Technical Service BULLETIN

COWL TOP VENTILATOR LOUVER SUB-ASSEMBLY

'96 - '98 RAV4

AC003-99

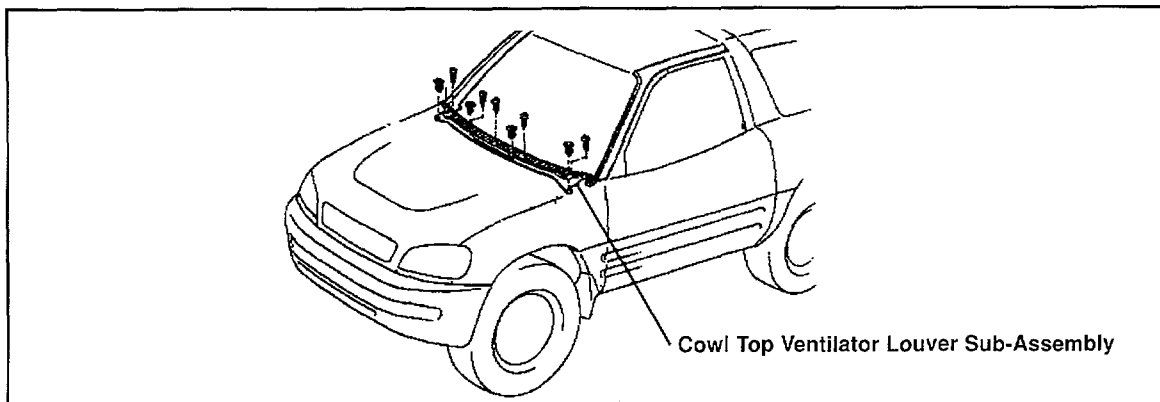
Introduction An improved Cowl Top Ventilator Louver Sub-Assembly is available as a field fix to help prevent snow from entering the Cowl Vent.

If during the process of diagnosing heater blower problems, the presence of water is noted in the Blower Assembly, replace both the Cowl Top Ventilator Louver Sub-Assembly and the Blower Assembly.
